RCRA Comprehensive Groundwater Monitoring Evaluation (CME) Report

LANDFILL #5
Utah Test and Training Range
Department of the Air Force
UT0570090001

Division of Solid and Hazardous Waste
Department of Environmental Quality
State of Utah

FIGURE 5 Groundwater Flow-direction Map 1995

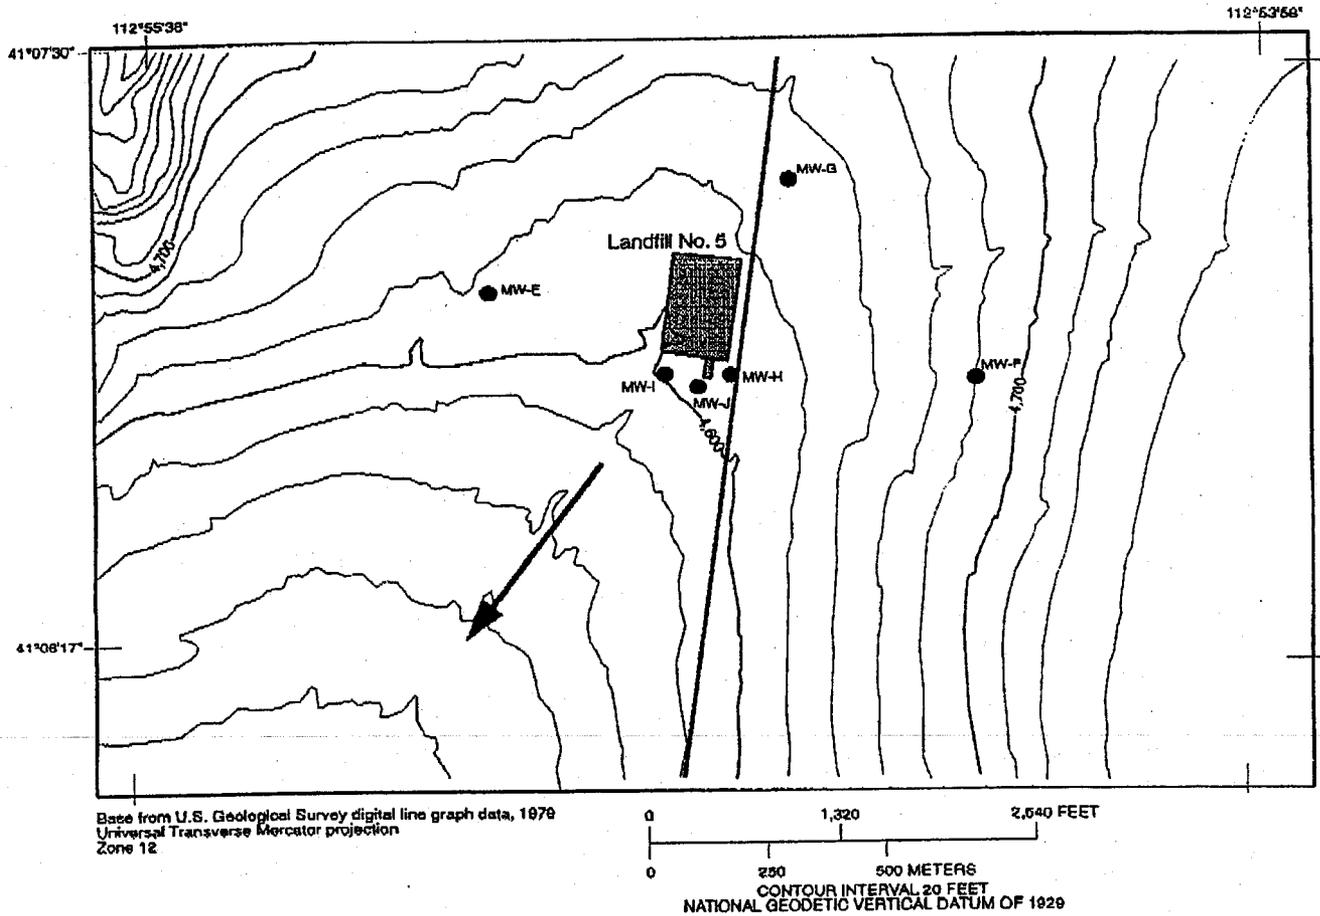
and 7). They show the groundwater flow direction going in three different directions in three successive years. This is particularly true for the 1995 data which shows north, south, and west groundwater flow directions within less than 1,000 feet of each other, all at the same time. In 1996 the flow direction was shown to be only to the south, and in 1997 the flow direction was shown to be only to the north.

There are several possible explanations for the confusing and conflicting groundwater flow directions. One is the groundwater elevations measured in the wells around Landfill #5 are incorrect. This could be caused by either bad down well measurement techniques, by incorrectly surveyed well tops, or due to wells that were not exactly plumb. Alternatively, Landfill #5 could sit at or near a groundwater high or divide. This setting would produce true groundwater flow away from a local groundwater high (either dome or ridge) in two or more directions. For this to be true the site must be a recharge zone. The physiographic setting of Landfill #5 is not that of a typical groundwater recharge zone.

FIGURE 8 Groundwater Contour Map 1999

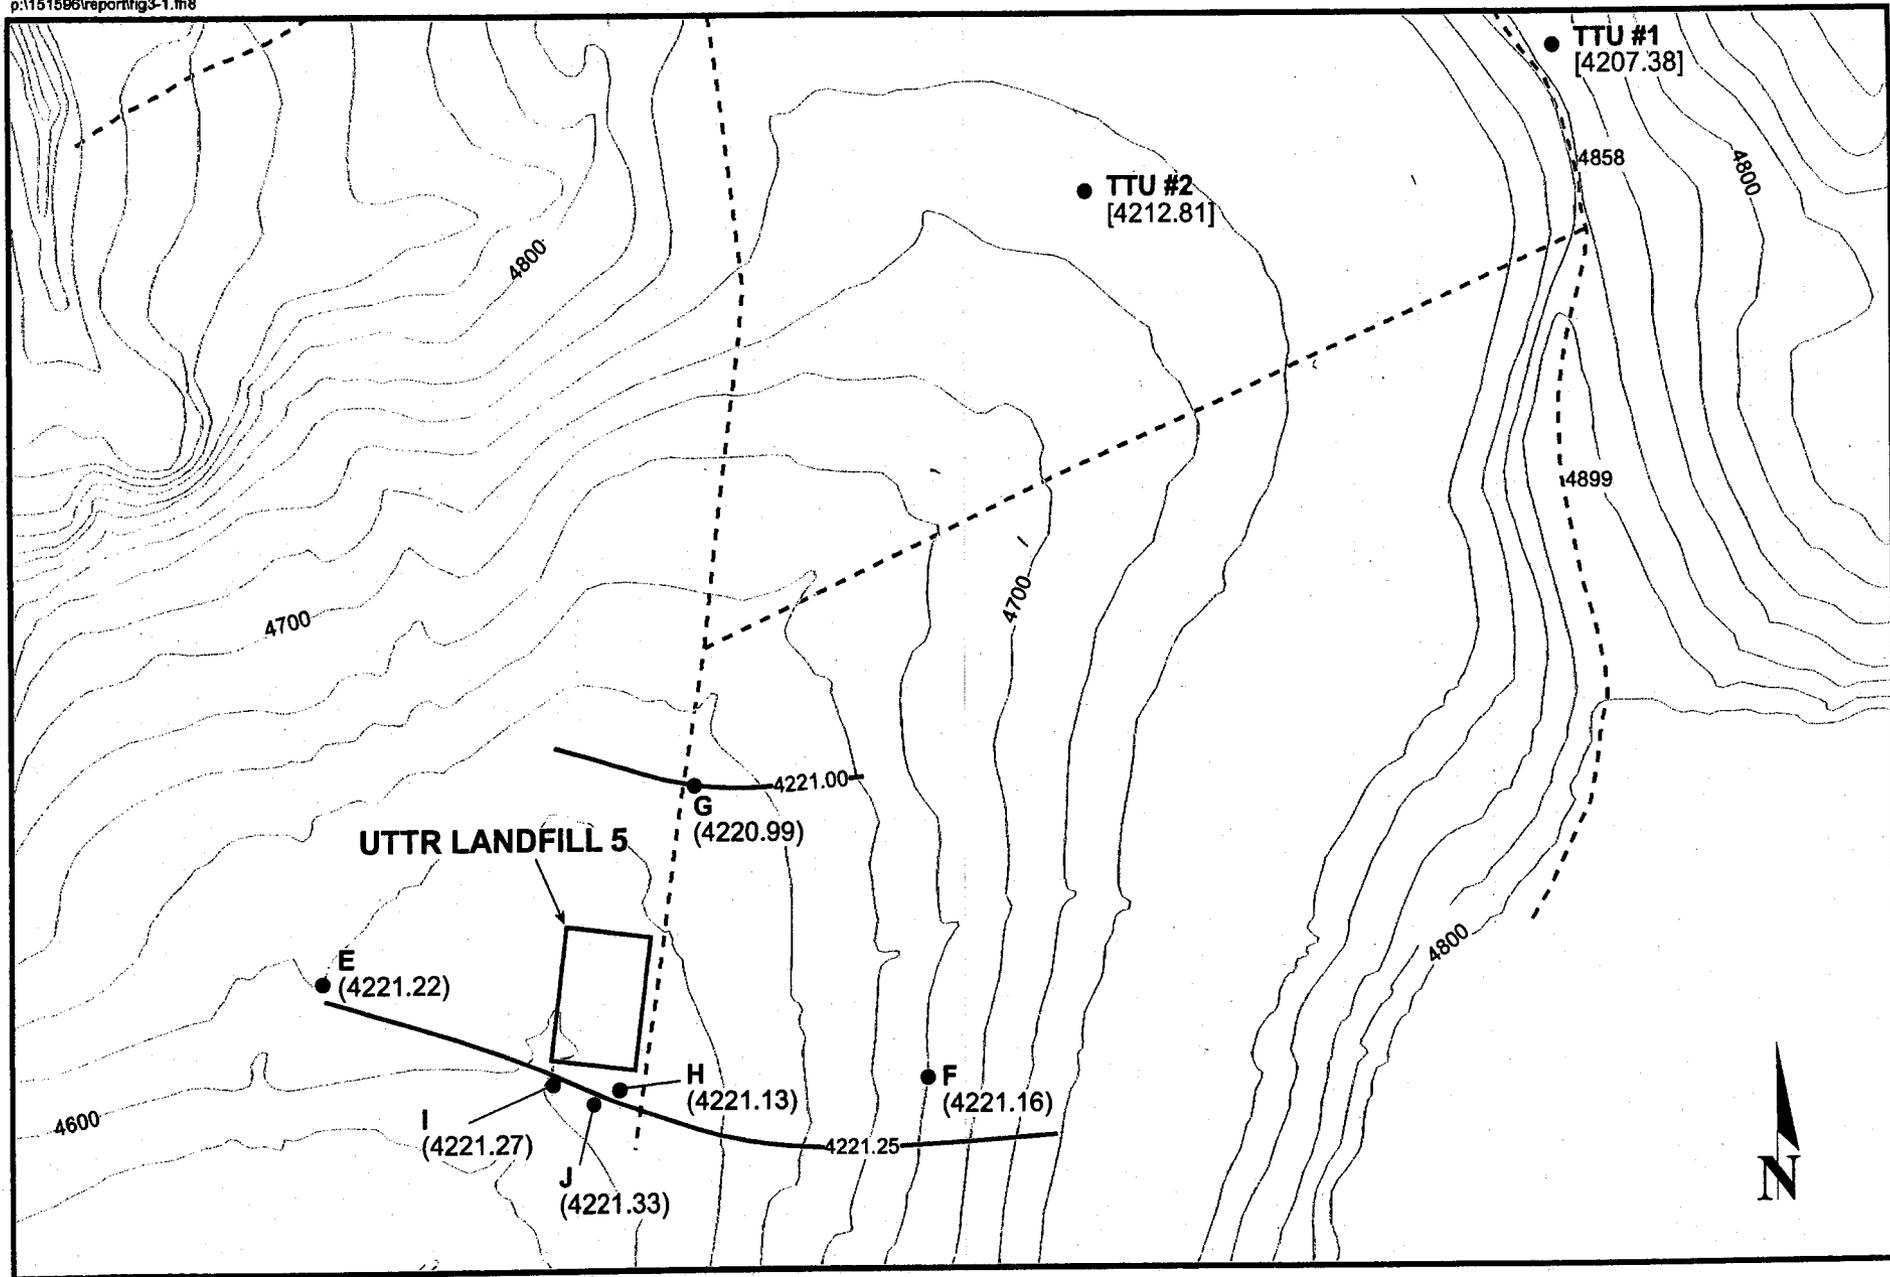
The data from this survey indicated that none of the Landfill #5 monitoring wells were vertically plumb. When a well is not plumb the down hole measurement is always longer than the true depth to groundwater, because down hole measurements are along the hypotenuse of a triangle and not down the vertical leg. These errors, which are rarely measured in RCRA groundwater monitoring wells, are all significant.

The inclination measurements were used to correct the static groundwater elevations, and then to generate a corrected piezometric surface contour map. Figure 8 shows the final corrected groundwater elevations and interpreted piezometric surface. The gradient slopes to the north, up valley, and then east through Sedal Pass. The wells at the TTU were not included in the inclination survey, so their groundwater elevations are not corrected. However, the expected elevation corrections for these wells (estimating from the average correction found for the Landfill #5 wells) is not sufficient to change the groundwater flow direction. It should be noted, that the final corrected data does show a very flat gradient of only 0.00018 feet/foot in the vicinity of Landfill #5.

Before this flow direction is considered for compliance purposes, additional semiannual monitoring events need to be conducted to verify the first round of truly accurate measurements.
